APPEAL SUMMARY

Appeal ID: 23501

Project Address: 203 NE Grand Ave

Building/Business Name: Grand Ave - Fairfield Residential

NW CORNER APPEAL

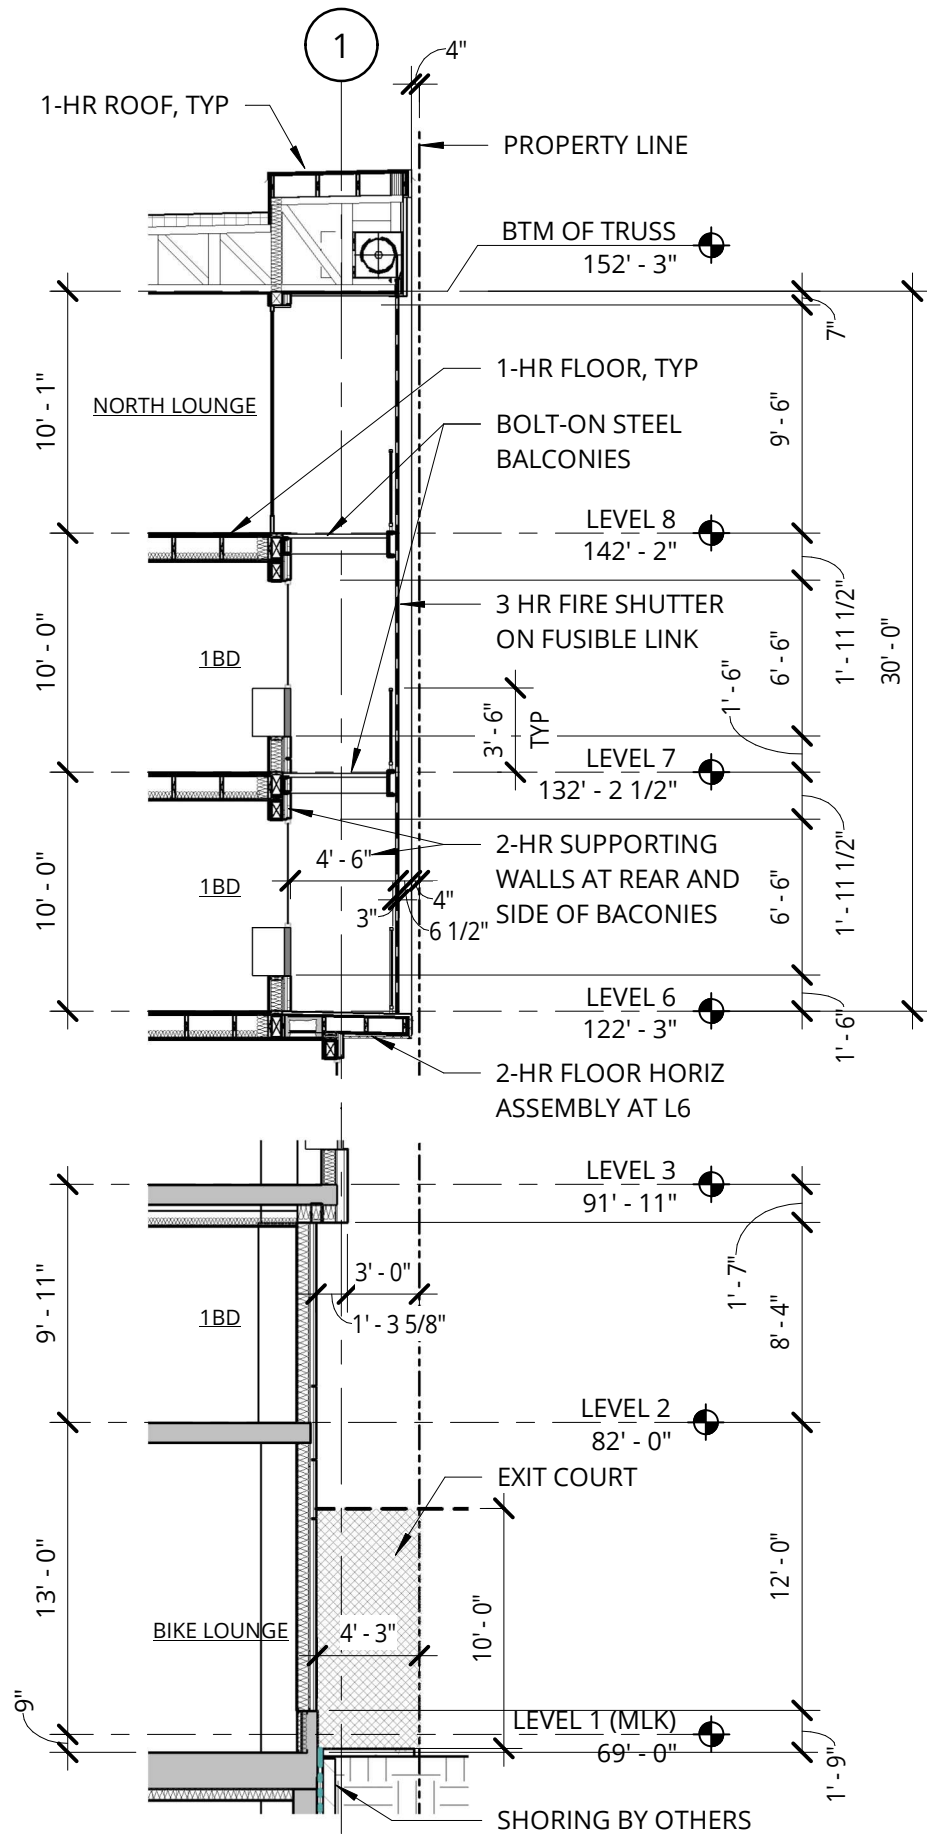
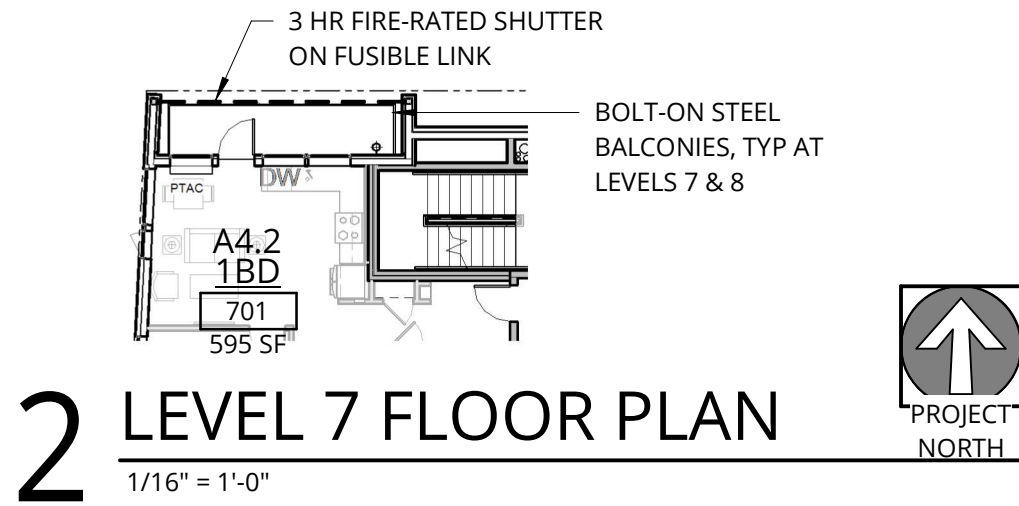
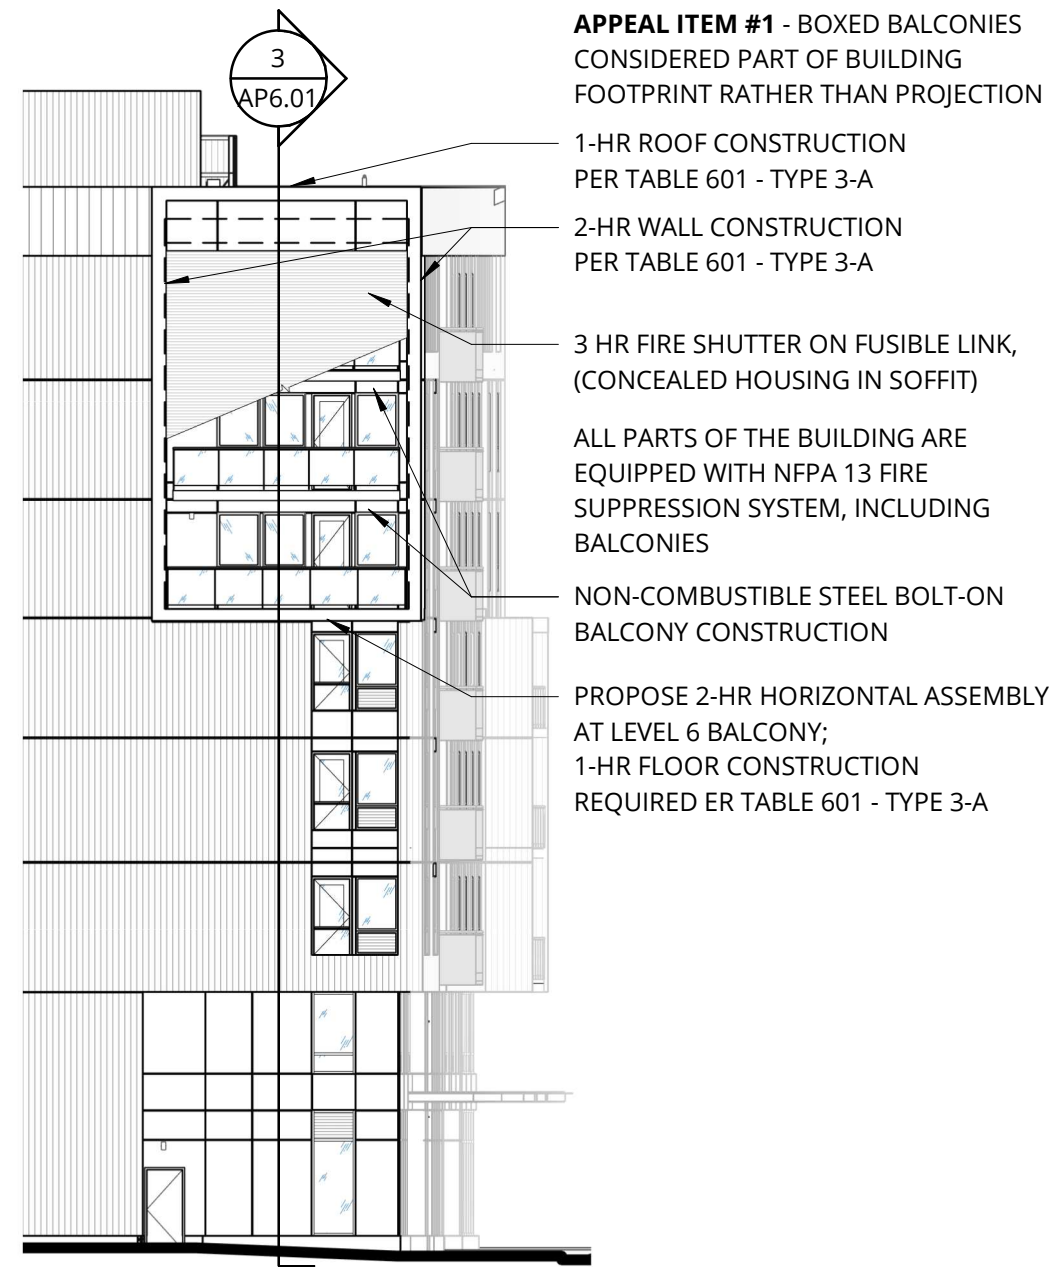
Provide equivalent protection to exterior wall elements by utilizing a fire-rated shutter on fusible link.

At the NW corner, however, this design element extends to within close proximity of the property line with the adjacent lot. This particular box starts at Level 6 and is part of the type III-A construction with 2-hour exterior bearing walls. Code prescribes 1-hour floors and supporting structural elements that form the box elements on these floors. Design team proposes to continue the 2-hour wall design at floors and roofs forming the box. The three story box frames steel balconies on all sides and will be covered by a 2-hour roof as prescribed in Table 601. The intermediate balconies are of steel, (non-combustible) construction, so does not present a fire hazard in terms of flammability or propagation. Every part of the exterior wall and roof that surrounds these balconies is constructed consistently with other structural elements at that floor. For this reason, the team would appeal that these elements are, in fact, part of the building enclosure and not a the type of projection defined by the code that would constitute a fire risk. As part of the building, they are also protected by NFPA 13 fire suppression system.

Project team proposes to use a large (20'x30') overhead coiling shutter, rated for 3-hr protection on a fusible link that will lower the shutter in the event of fire. Shutter motor, housing and steel jamb elements to be recessed into soffit and wall framing to conceal them from view. Shutter will enclose all projected elements that are within the prohibited zone, (<3'-0" from property line). Floor at Level 6 will be upgraded to 2-hour horizontal assembly to be consistent with enclosing wall elements.

Reduction in minimum required fire separation distance of balcony projections: Hold for additional information.
